SUBJECT: Forwards responses to NRC 800929 request for addl info re industrial exposure, offsite doses & accident evaluation. Questions were discussed at public meeting between respective staffs on 800917.

November 4, 1980
L-80-371

Re: Turkey Point Units 3 & 4
Docket Nos. 50-250 & 50-251
Steam Generator Repair

FIGURE 3-1

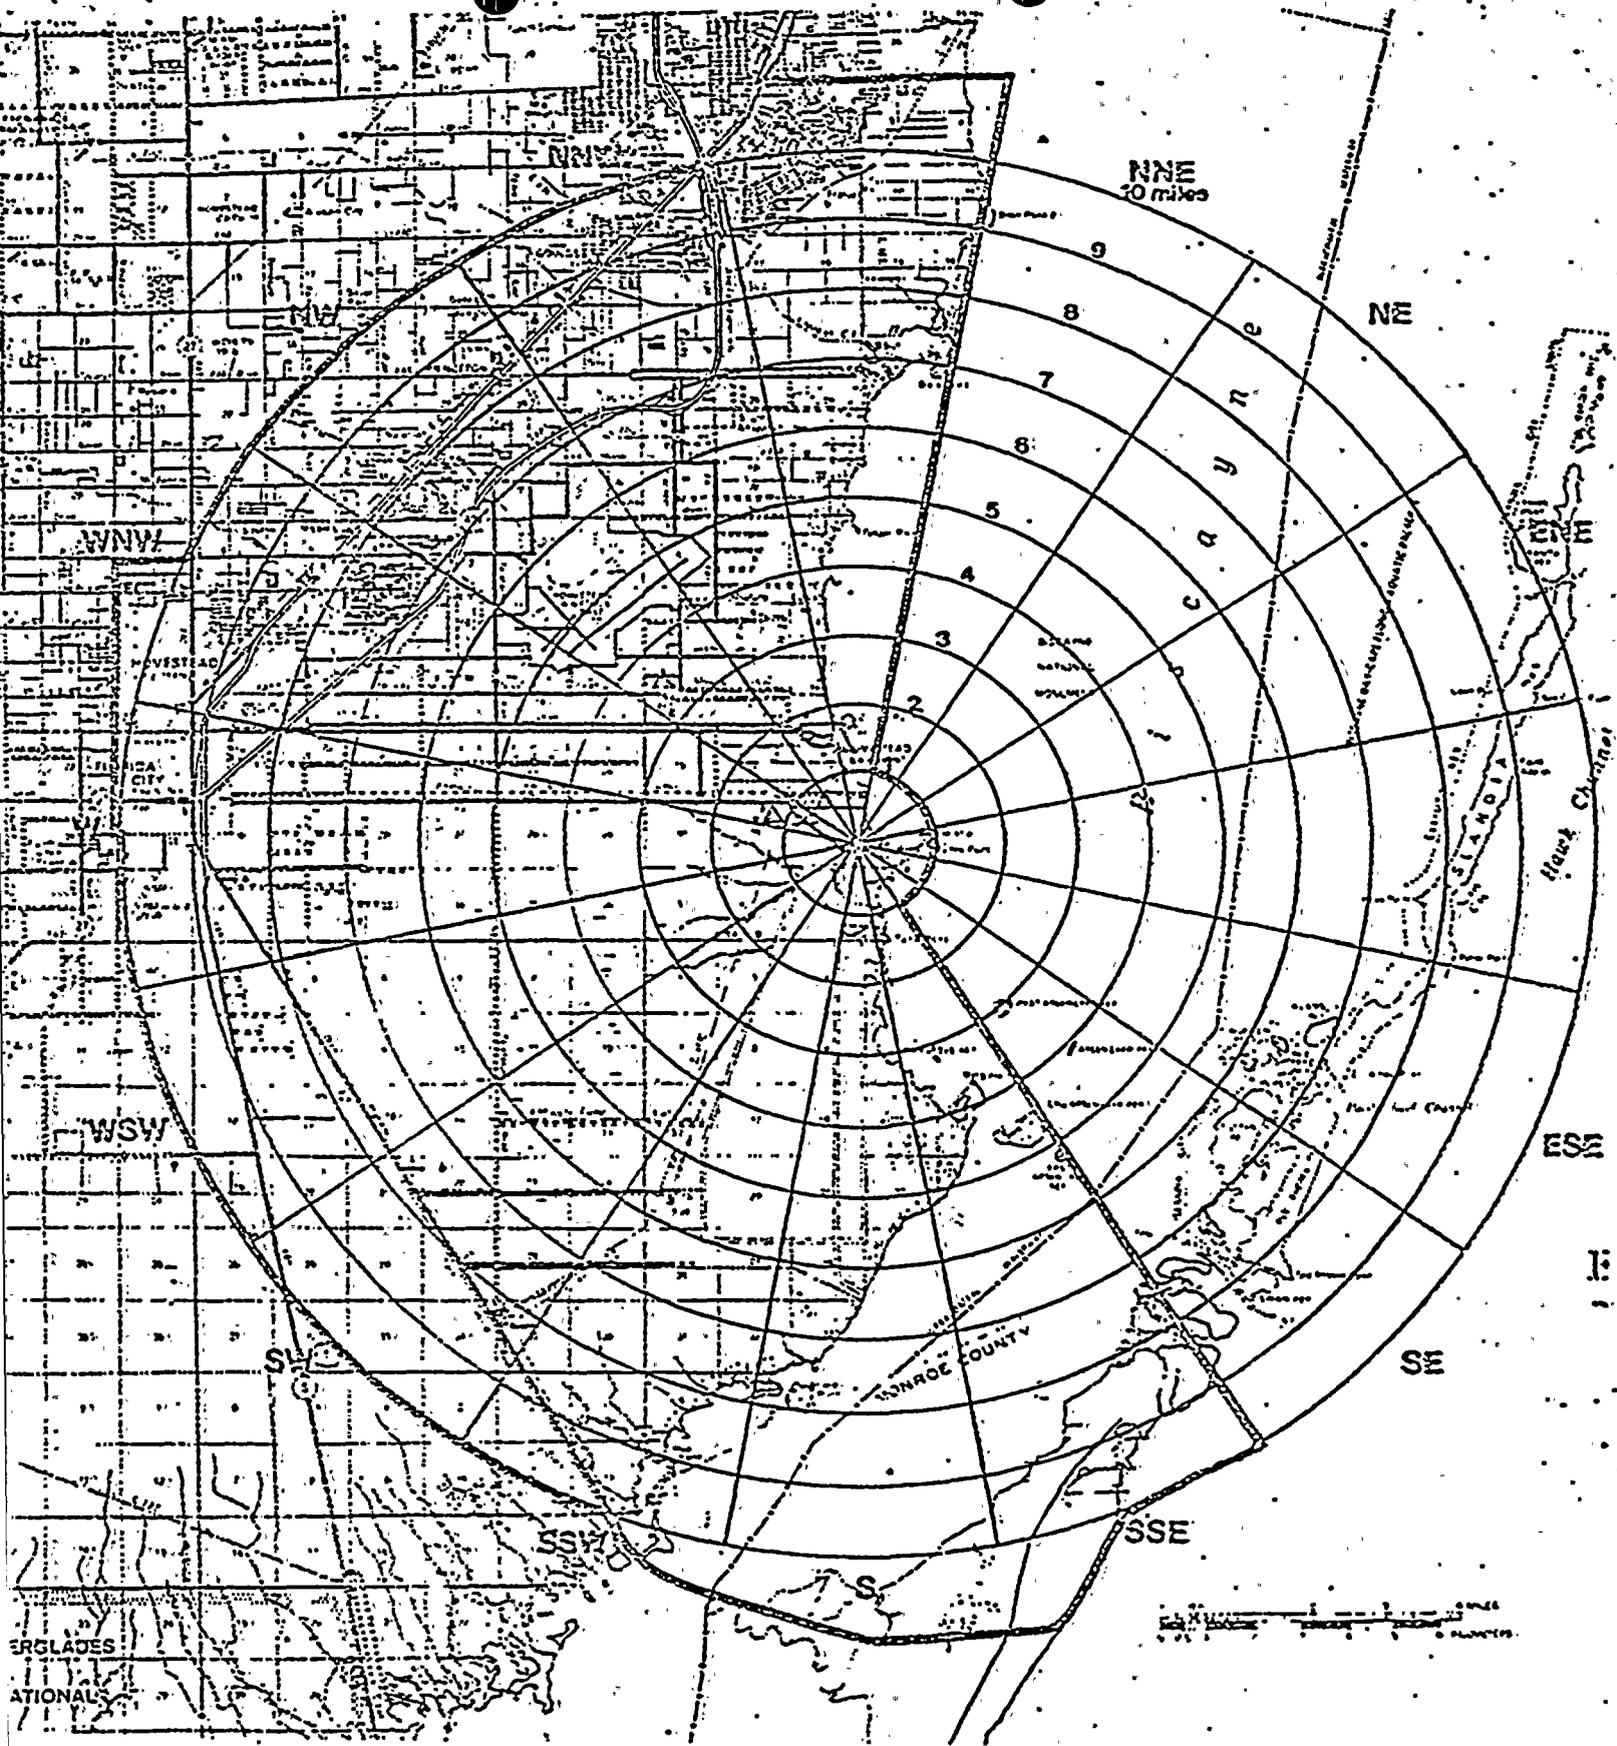
Identify (i.e., give distance and direction from the site) "the worst site boundary location" referred to on p. 5-22. Provide a table that lists the nearest full time residence, garden, cow and meat producing animals in each sector.

The attached Table provides the requested information out to 5 miles. The worst site boundary location is shown in the Turkey Point FSAR, Figure ID-1 (location at 360 degrees north). The distance to this location is 4164 feet (see FSAR, page 2.13-1). An aerial view is shown on FSAR Figure 2.2-2.

FIGURE 1

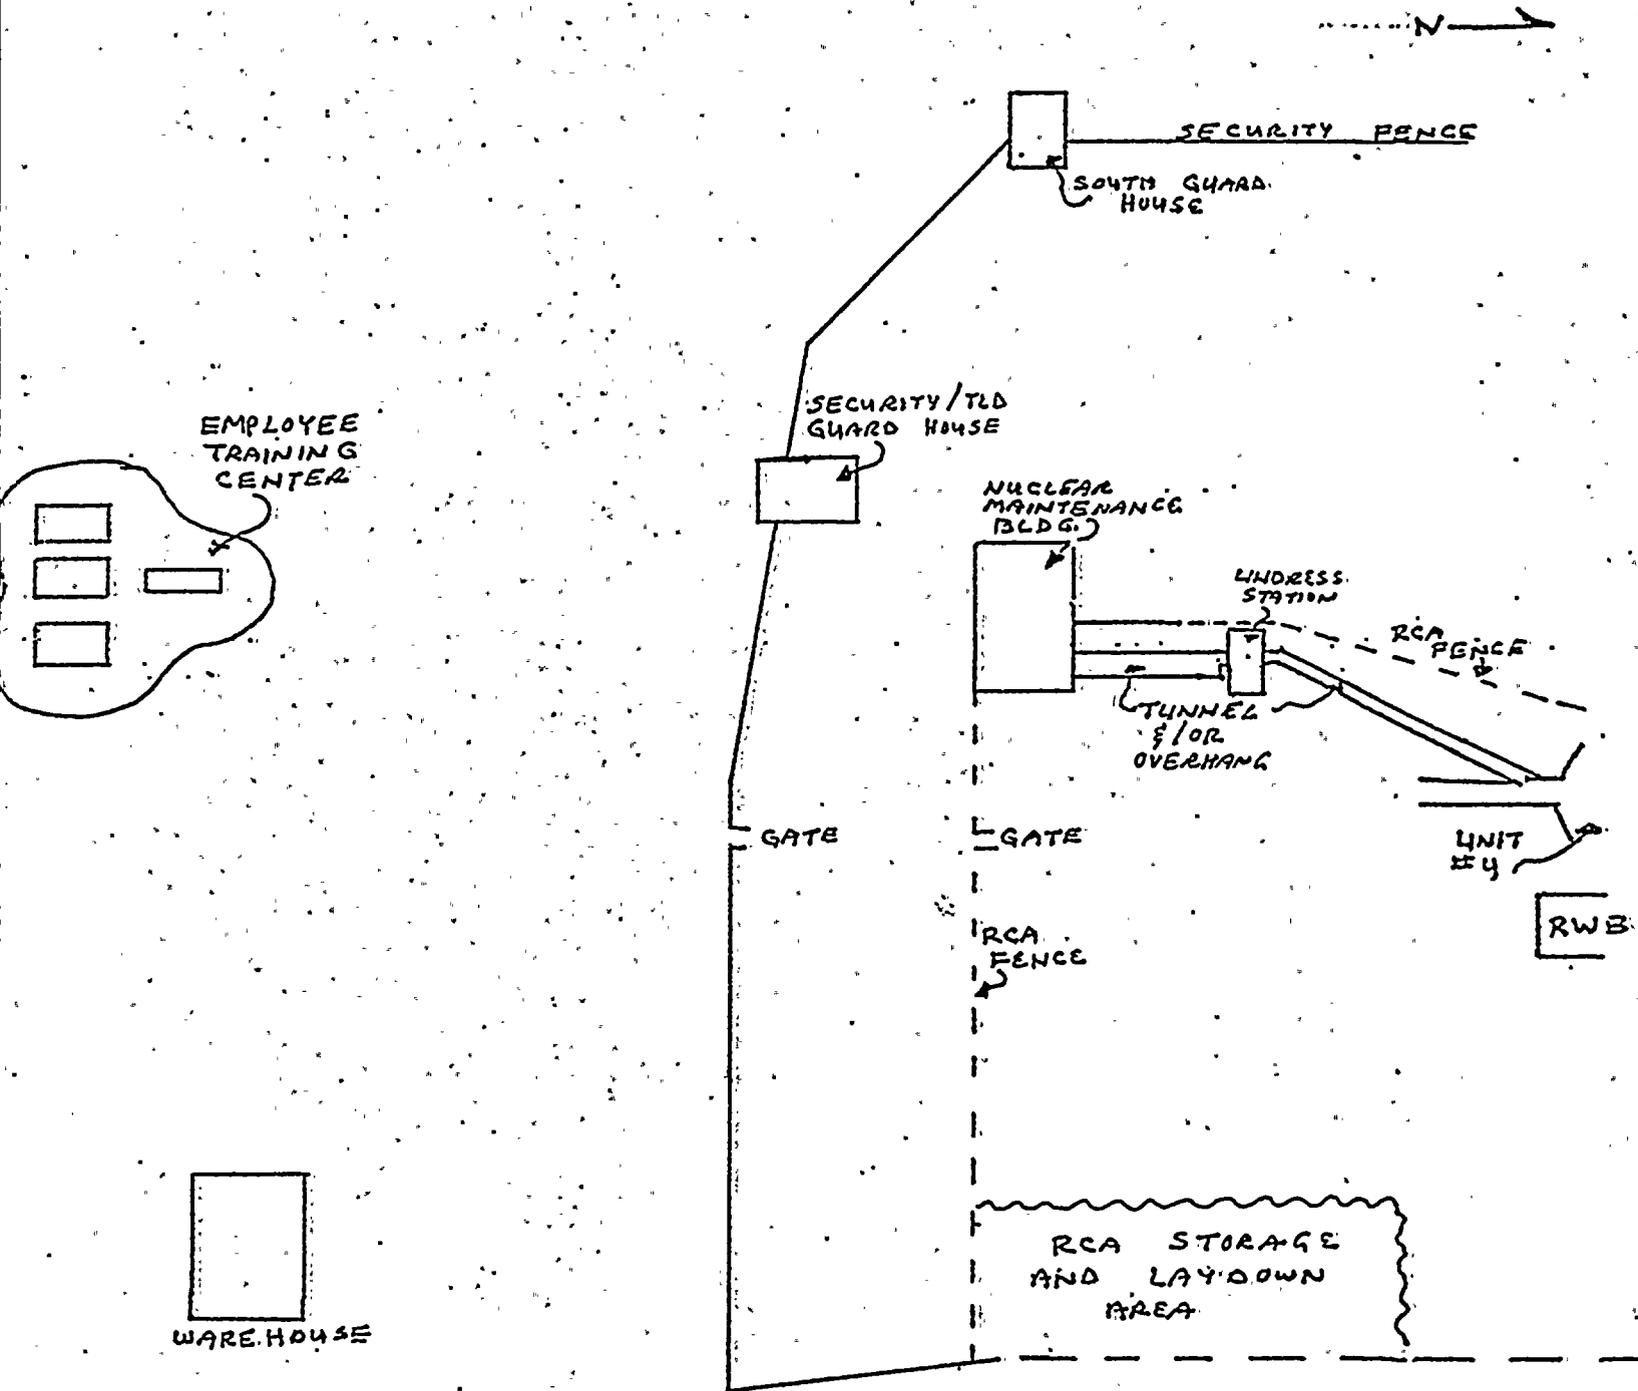
4. Your response to question 10 of our July 29, 1980 letter is incomplete. Provide a drawing showing location of new facilities including change room, access control station, laboratory facilities and decontamination facilities.

A conceptual outline (including drawings) is attached. It is for planning purposes only and is subject to change.

Figure 1 reveals the general layout for the Unit #4

Steam Generator Replacement Outage with the locations of major buildings associated with health physics activities presented. These buildings consist primarily of:

1. Employee Training Center (Figures 1 & 2)
2. Security/TLD Guard House (Figure 3)
3. Nuclear Maintenance Building (Figure 4)
4. Tunnel and/or Overhang
